Proposed Front Porch Rebuild

2. New Proposed **Back Porch Options**

3 Revised **Proposal for Rear Elevation**

Revised **Proposal for Rear Elevation**

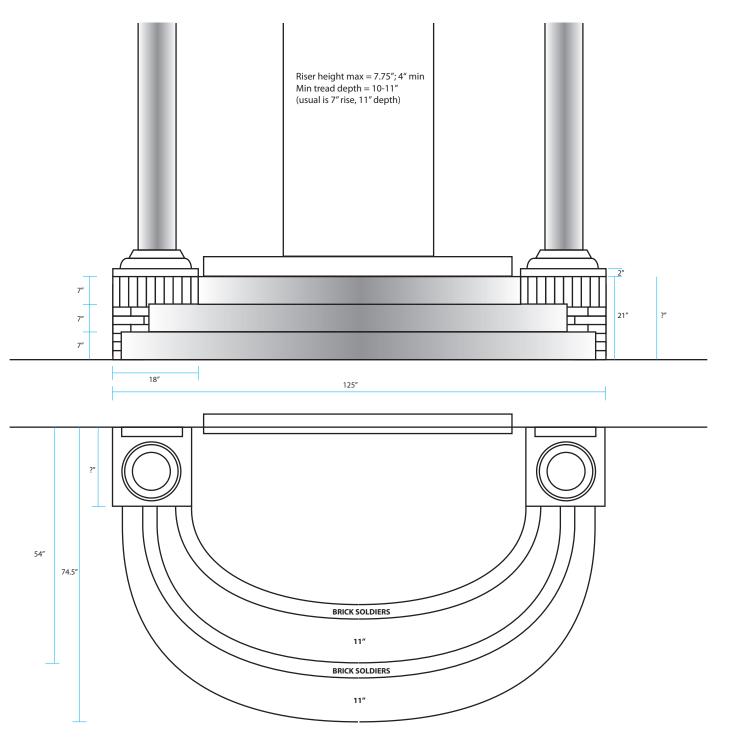
The front porch was not salvageable. The stairs were crumbling and the entire porch needed to be replicated. Please note that we fabricated a template to memorialize the original shape of the steps.

We made measurements and created a drawing of the as-built conditions to follow. (Drawing at right).

Parts of the front sidewalk also needs to be fixed due to pitching towards the house, something that has compromised the integrity of the support beam (which has been fixed). We will either re-pour the concrete or try and level the existing pads. Whether that is possible is yet to be determined. Note: We have restored the wood columns.

Original Plan View

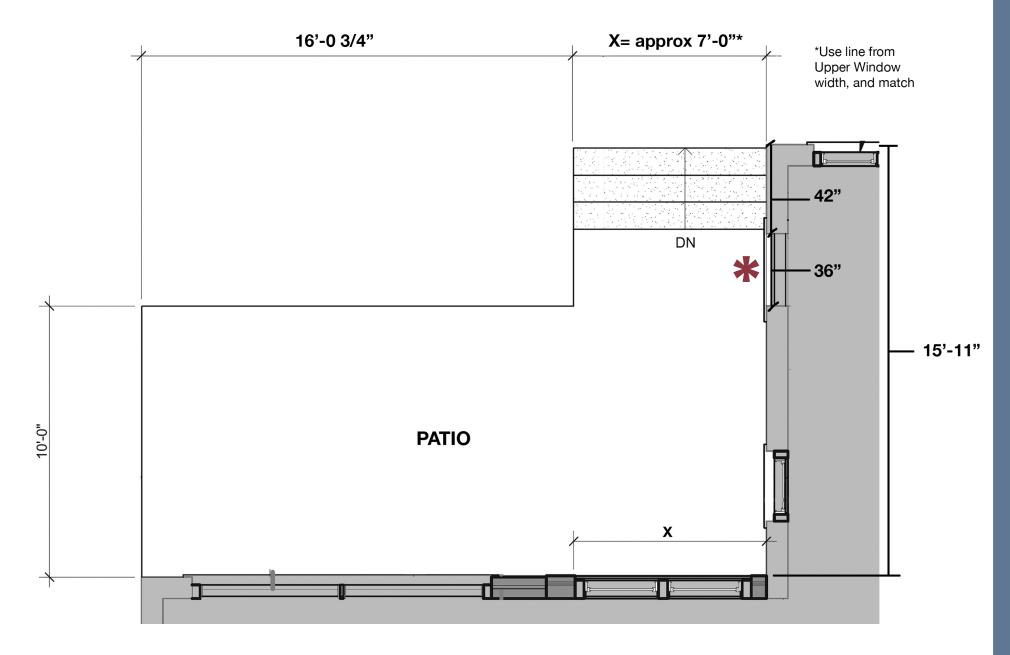
This layout was previously presented to the Historic Commission.

Unfortunately this configuration does not work due to the actual elevation. Somehow the scanned exterior of the house documents were inaccurate and 5 or 6 stairs are necessary to reach the first floor entry (indicated with an asterisk above).

As you will see the extra stairs would extend beyond the existing opening to the entry at right. This miscalculation caused us to have to rework the configuration of the back porch.

2b. Back Deck Option B

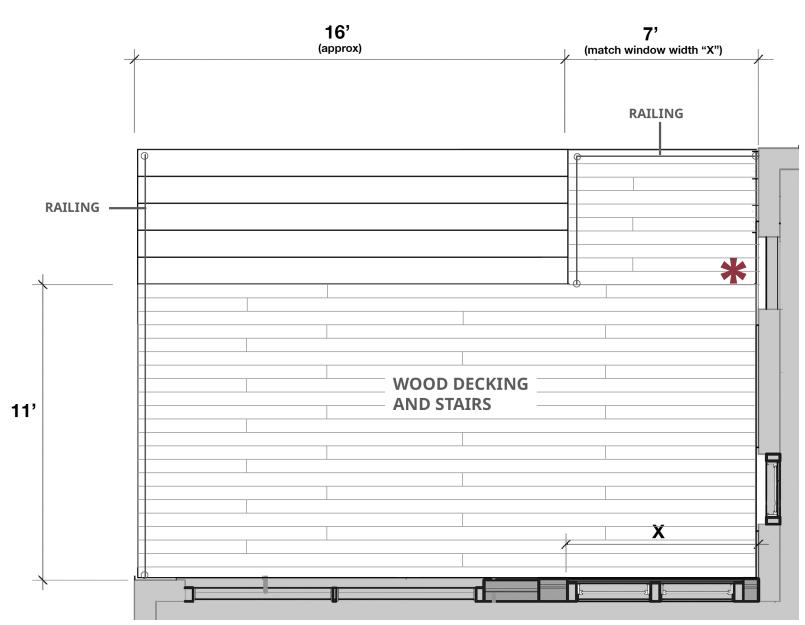
Wood deck design approach

This deck option is a function of potential budgetary issues with the brick and mortar Option A. We have gotten several price quotes that are exorbitant and we are considering the probability that this option will be much more economical. This version would only require concrete footers and cedar or similar hardwood floorboards and structure. The design would include Historical design appropriate railings and side walls along the east and north sides of the deck hiding the elevation. Plantings will be done to soften the rise.

Revised Rear Elevation

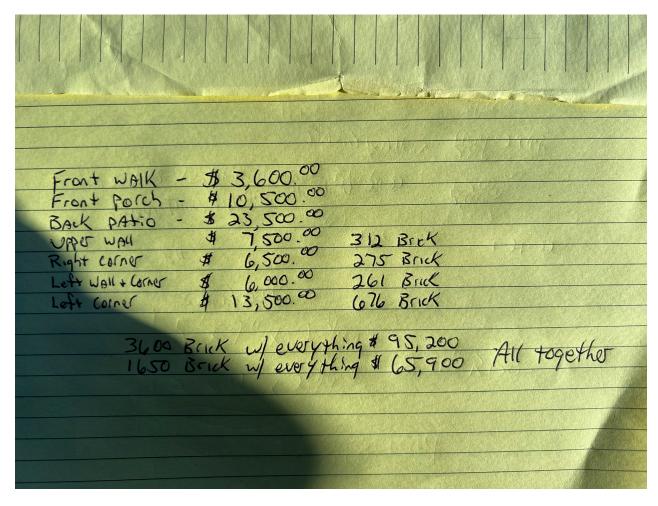
This version depicts the use of wood or Hardy Board instead of brick cladding. This will save many thousands of dollars in the expenses of brick masons and masonry materials.

Above is a rendering of the rear of the house with infill of wood or Hardy Board. Please note that the porch design shown is Porch OPTION A, but could also be Deck Option B instead. The original house back had stucco and brick, but also an expanse of windows on the first floor. That floor

completely fell down years ago, but would have read as a wood structure when it was intact. If painted the tan of the shake this would blend into the brick nicely and be attractive and more economical. The established brick pattern with its soldiers and limestone sills will be complicated and expensive to execute with at least 9 windows and doors that reguire such detailing. Note that this rendering does not portray the soldiers. Another consideration is the possibility of not finding an adequate brick match. Common brick will not be acceptable and would look worse than wood. Of the three

options: brick, stucco and wood or Hardy board, the latter is the most economical. I am happy to continue looking into pricing, but the quotes on the next page are from two years ago and I believe they will be even more expensive today.
